Cowal Gold Operations Open Pit Continuation Project Submissions Report

Prepared for Evolution Mining (Cowal) Pty Ltd
January 2024

Submissions Report

J190417 RP52

Evolution Mining
Cowal Gold Operations
Open Pit Continuation Project
Submission Report
Figure 4.7

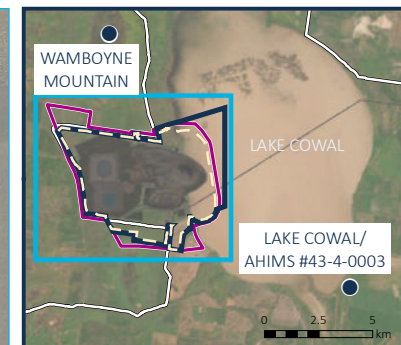
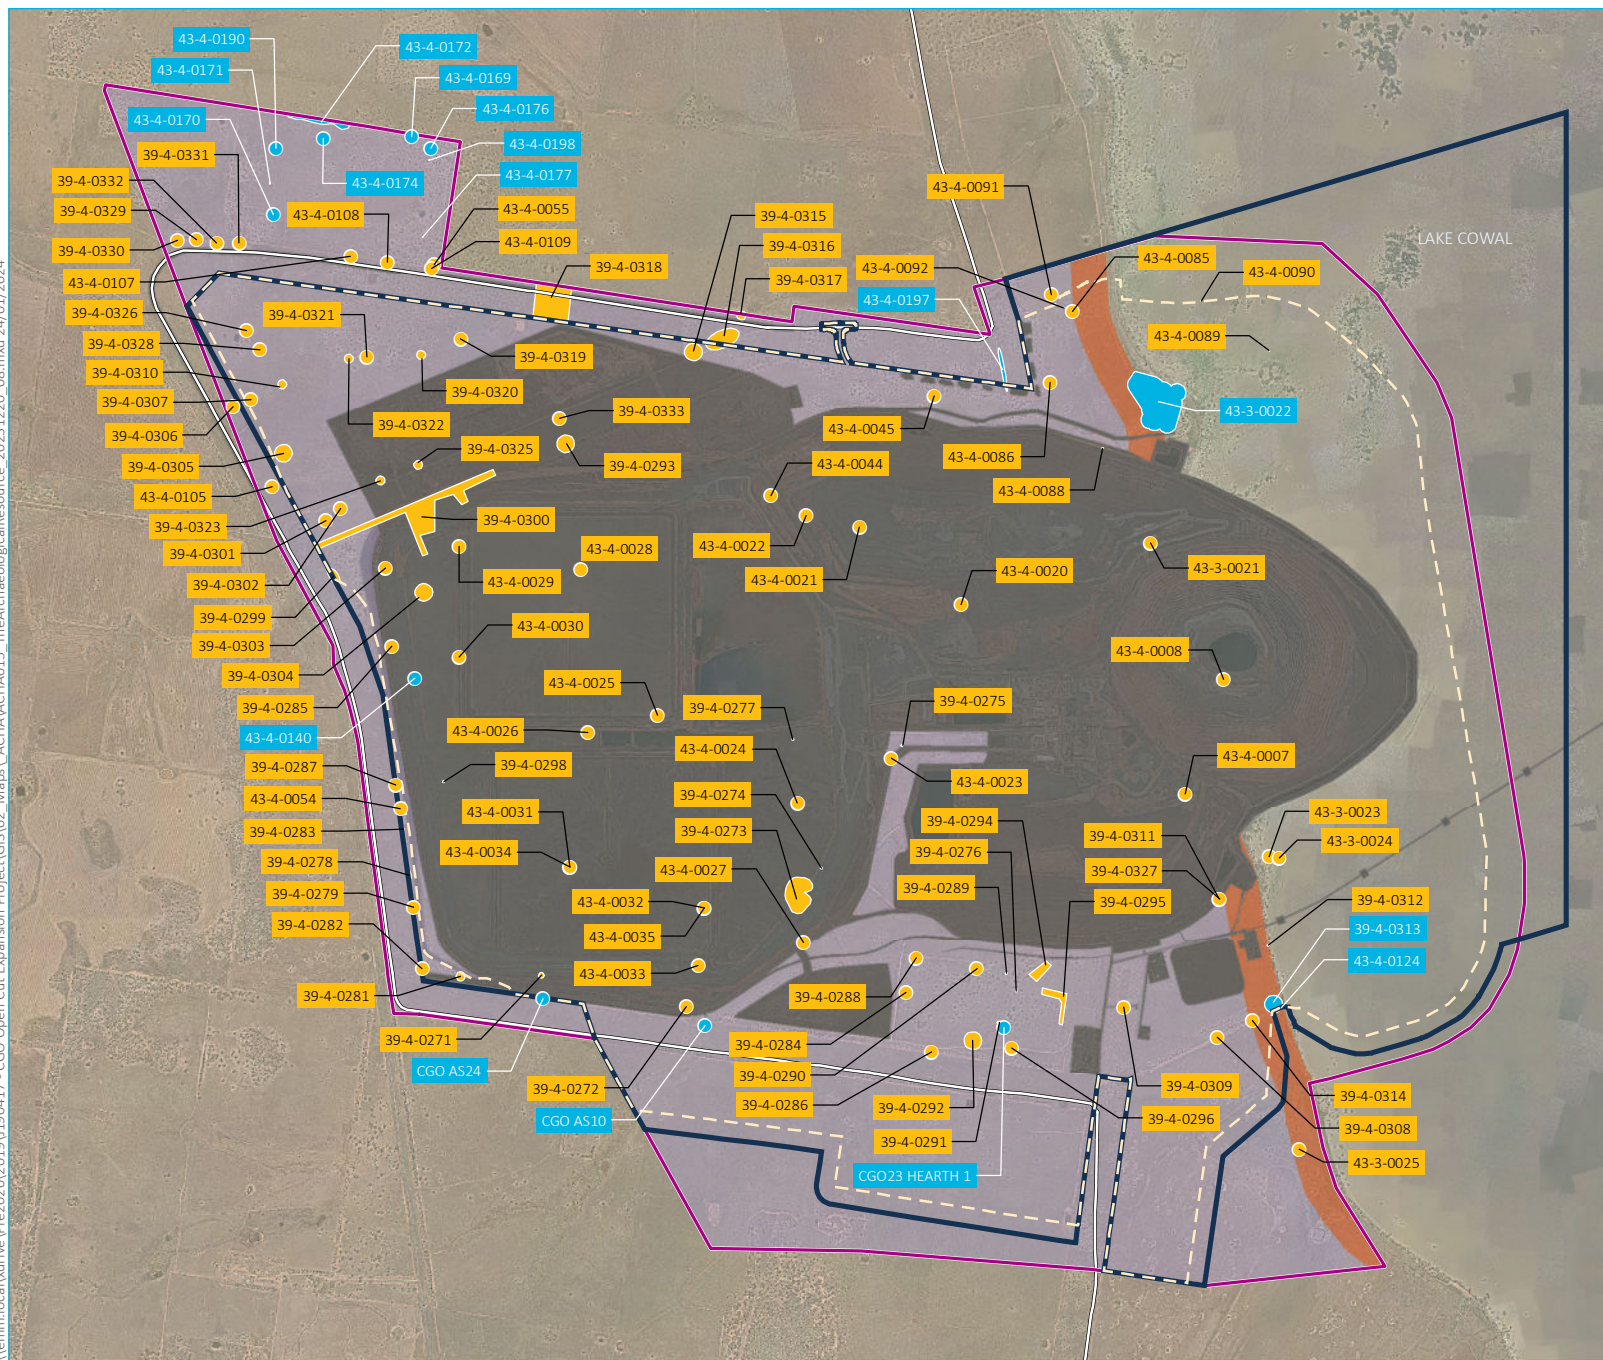
Please update figures to include polygons of all sites (both valid and destroyed) across the project area to provide greater clarity on the spread of Aboriginal cultural heritage.

Section 4.3 of the Addendum ACHA discusses the revised archaeological resource which is presented in Figure 4.7. Additional figures are available in the Addendum ACHA with respect to hearth investigations undertaken including those existing and destroyed.

Evolution Mining
Cowal Gold Operations
Open Pit Continuation Project
Submission Report
Figure 4.8

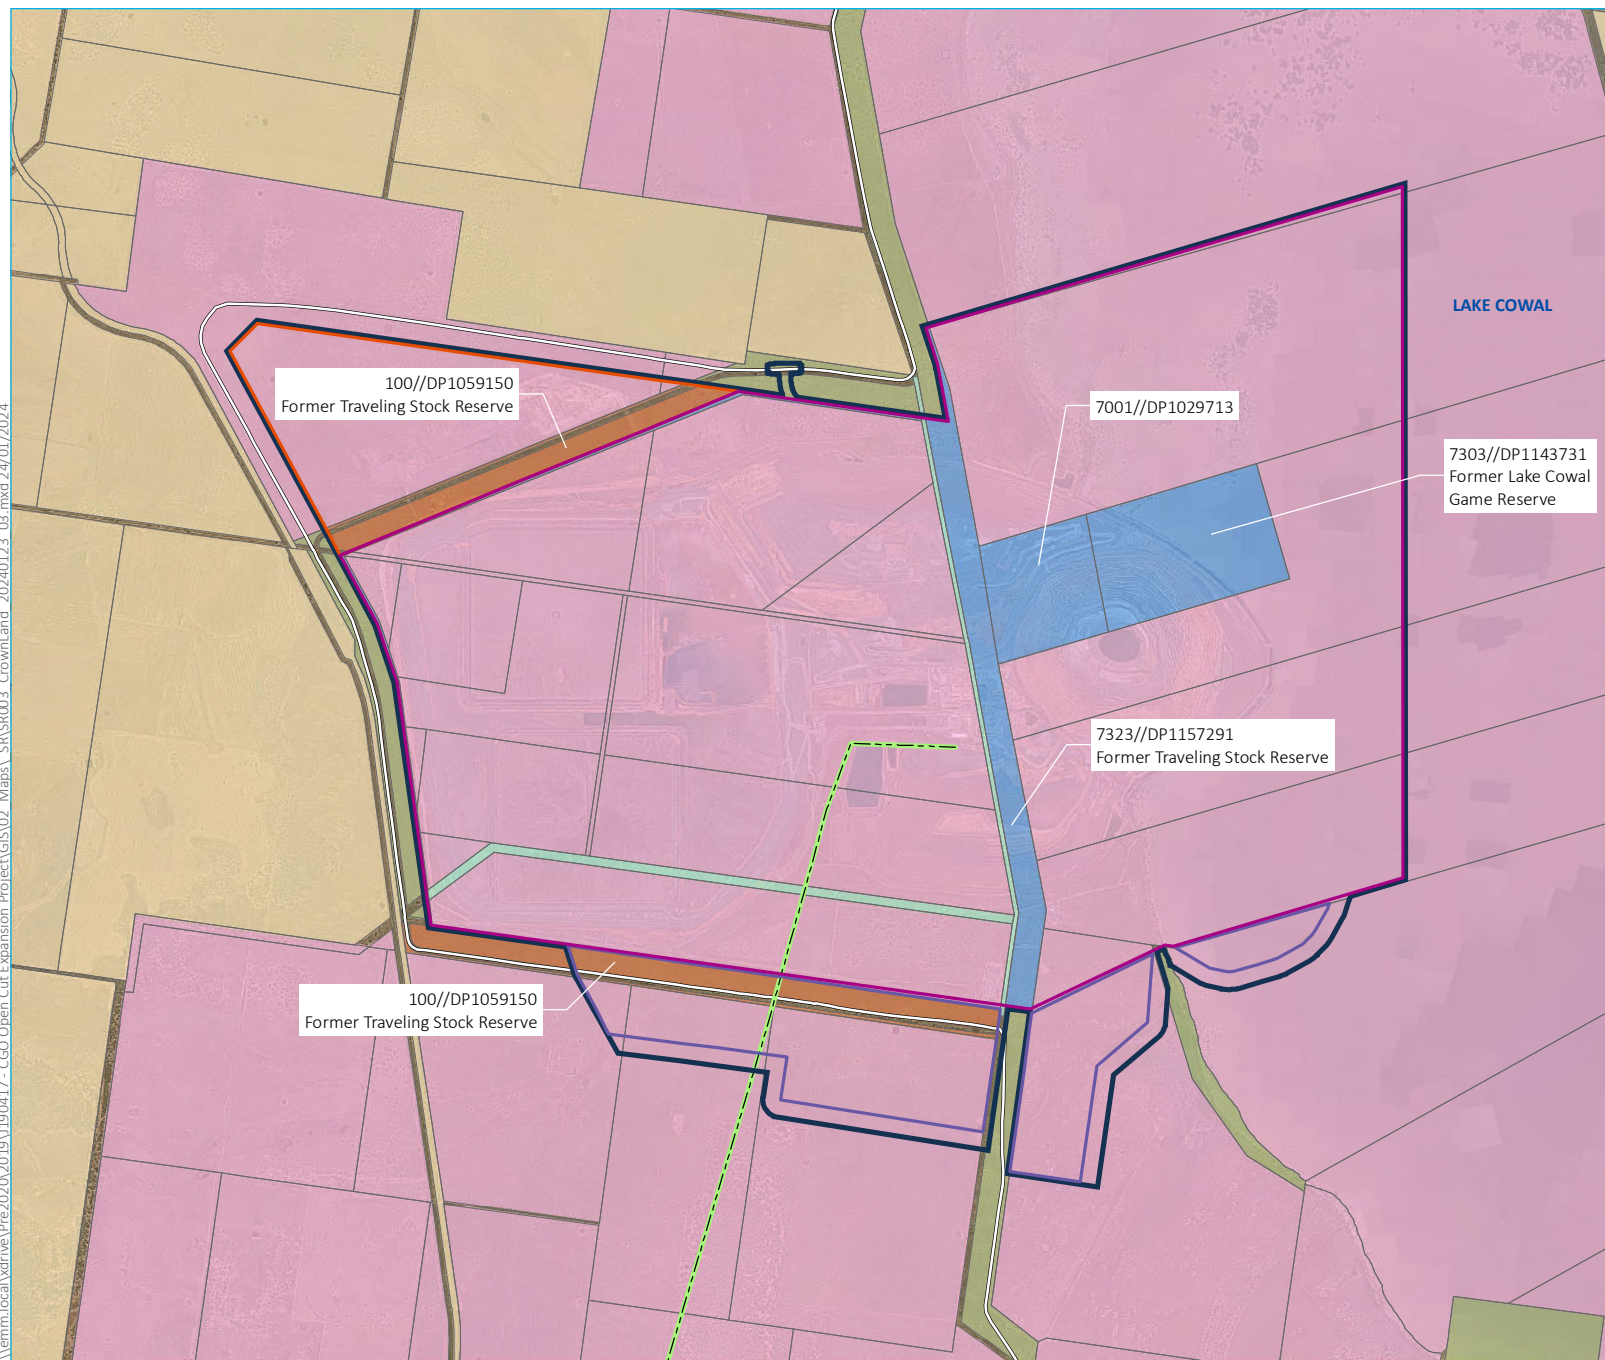
In order for transmission lines to traverse Crown land and/or roads, the proponent will need to apply for easements. As the easement process may be lengthy, it is also recommended that the proponent apply for a licence for each Crown road and Crown land lot as soon as possible. A licence will be temporarily authorise use and access for the infrastructure to traverse Crown roads and Crown land whilst the easement applications are being processed.

It is important to note that licences or easements must be in place before infrastructure can traverse Crown land or roads.

It is important to note that authority must be in place before Crown land or roads can be used, traversed, accessed or infrastructure can be built.

The Project does not include additional linear infrastructure. However the existing external water supply pipeline will be redirected around the new open pit mining areas within the existing ML. The final alignment of this water supply pipeline realignment within the ML is yet to be finalised however there is the potential that the pipeline realignment may traverse Crown Land parcels within the ML.

An application for the grant of a Mining Lease has been lodged by Evolution on 29 September 2023, now designated Mining Lease Application No 638 (1992) (MLA 638). MLA 638 covers an area of approximately 345 ha and encompasses the surface to depth of 20 m, inclusive of the surface. Figure 4.8 shows the area subject to MLA 638.

Figure 5.2 Proposed Lake Protection Bund Level-Volume Graph (ATC Williams 2024)

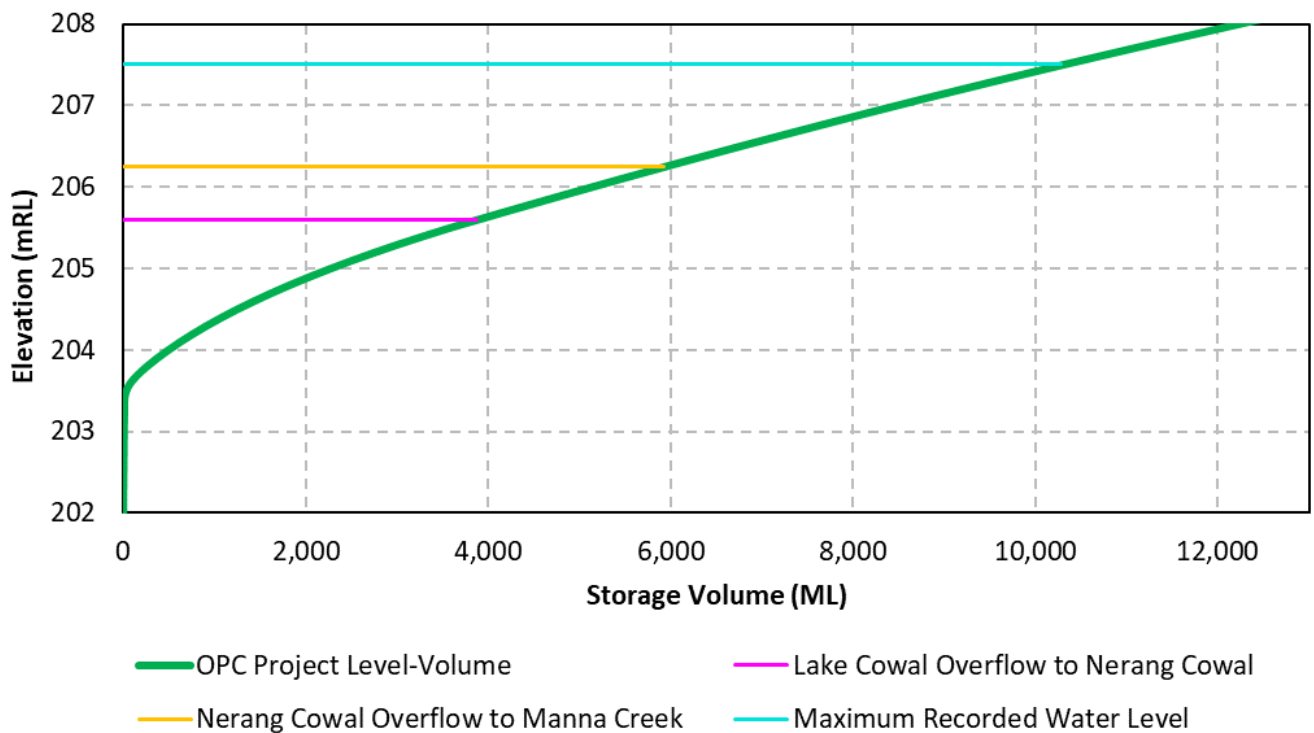
The key theme raised in the local objection related predominantly to the potential for the expanded LPB to increase flood levels within Lake Cowal. A detailed response to the themes raised in this submission is provided in Section 5.2.2.

The level-volume graph for the area behind (upslope of) the proposed expanded LPB is provided below in Figure 5.2. The LPB is estimated to displace approximately 3,900 ML at 205.6 mRL, the estimated level at which Lake Cowal overflows to Nerang Cowal.
